**SUBJECT:** Response to NRC Request for Additional Information Pertaining to  
Request for Alternative ANO2-R&R-002, Rev. 1

Arkansas Nuclear One, Unit 2  
Docket No. 50-368  
License No. NPF-6

**REQUEST FOR ADDITIONAL INFORMATION REGARDING  
REQUEST FOR ALTERNATIVE ANO2-R&R-002, Rev. 1**

CALCULATION CN-CI-02-6, REV 0, "Analysis of ANO-2 Pressurizer Heater Sleeve MNSA-2 Designs" dated March 21, 2002<sup>1</sup>

Appendix B2: Grafoil Seal Transfer Coefficient

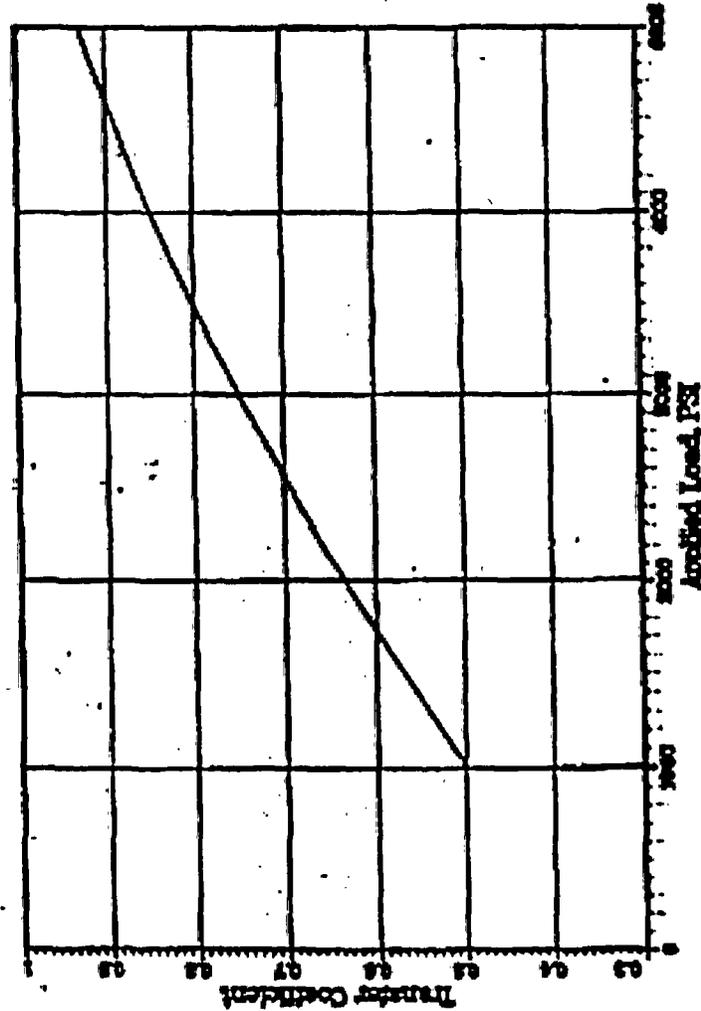
- 1.0 Section 3.1.4, "Sealing Pressure," (page 9) states that the radial pressure against the pressurizer (PZR) bore and the heater sleeve is at least 80% of the axial pressure. Please indicate where this determination is demonstrated in Reference 6 of the calculation.

*The Grafoil Literature Sheet, documented in Union Carbide Corporation's Engineering Design Manual, Vol. 1 (Reference 6 of CN-CI-02-6) and provided in Attachment 1, shows the increase in radial load transfer with applied axial load. As evidenced from the graph, a transfer coefficient of 80% results in an applied load of 3,500 psi.*
